Access Compliance Report

Public Rights-of-Way

Intersection ID: 2507	Main Street: CAMBRIDGE_BAY_DR	Cross Street: SNOW_HILL_CT	Location: S
ADA ID: C7356D929385	Ramp Type: PerpDiag	Initial Pass/Fail: Fail	Overall Compliance: No
Severity Score: 26.25			
Codes/Mitigation Info/Possible Solution		Field Measurements/Component Compliance

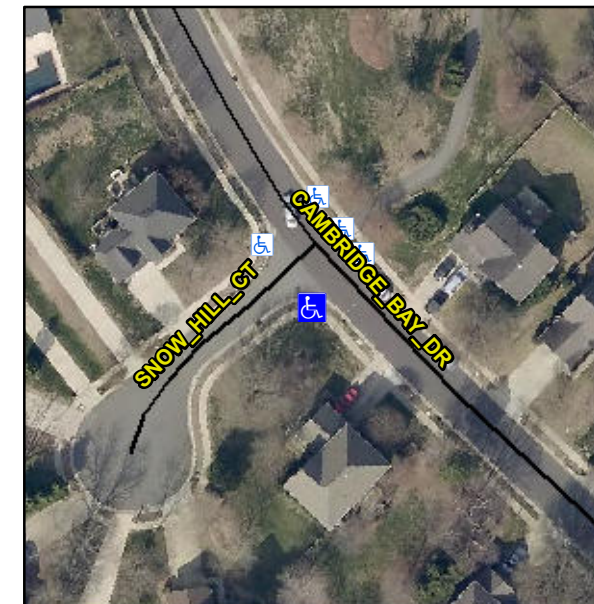
Not Found, R304.2.2, R304.5.3

Compliance	Description	Data	Compliance	Description	Data
N/A	Ramp Length (in)	47.0	No	Ramp Slope (%)	12.5
Yes	Ramp Width (in)	48.0	No	Ramp XSlope (%)	2.4
N/A	Flare Type LT	N/A	N/A	Flare Type RT	N/A
N/A	Flare Slope LT (%)	N/A	N/A	Flare Slope RT (%)	N/A
N/A	Flare Traversable LT?	N/A	N/A	Flare Traversable RT?	N/A
N/A	Landing Length (in)	N/A	N/A	DWS Provided?	N/A
N/A	Landing Width (in)	N/A	N/A	DWS Contrast?	N/A
N/A	Landing Slope (%)	N/A	N/A	DWS Length (in)	N/A
N/A	Landing X Slope (%)	N/A	N/A	DWS Full Width?	N/A
N/A	Landing Curb? (Y/N)	N/A	N/A	DWS Offset (in)	N/A
N/A	Shared Landing?	N/A			
N/A	Gutter Ponding?	N/A	N/A	Gutter Slope (%)	N/A
N/A	Gutter Lip Ht (in)	N/A	N/A	Gutter X Slope (%)	N/A
N/A	Painted X Walk1?	No	N/A	Painted X Walk2?	No
	X Walk 1 Direction	To NE		X Walk 2 Direction	To NW
N/A	X Walk 1 Width (in)	N/A	N/A	X Walk 2 Width (in)	N/A
	X Walk 1 Slope (%)	4.4		X Walk 2 Slope (%)	4.2
	X Walk 1 X Slope (%)	4.5		X Walk 2 X Slope (%)	1.8

N/A	Ramp inside XWalk1?	N/A	N/A	Ramp inside XWalk2?	N/A
	Road Slope (%)	2.0	N/A	Clear Space?	N/A
	Road X Slope (%)	8.6	N/A	Clear Space to XWalk (in)	N/A
N/A	Any Obstructions?	N/A	N/A	Storm Grate/Utility Hazard?	N/A
	Obstruction Type			Storm Grate/Utility Type	
		N/A			N/A
			Yes	Surface Condition? (G/P)	Good

Remove & Replace Curb Ramp With Two New Directional Ramps or Equivalent.
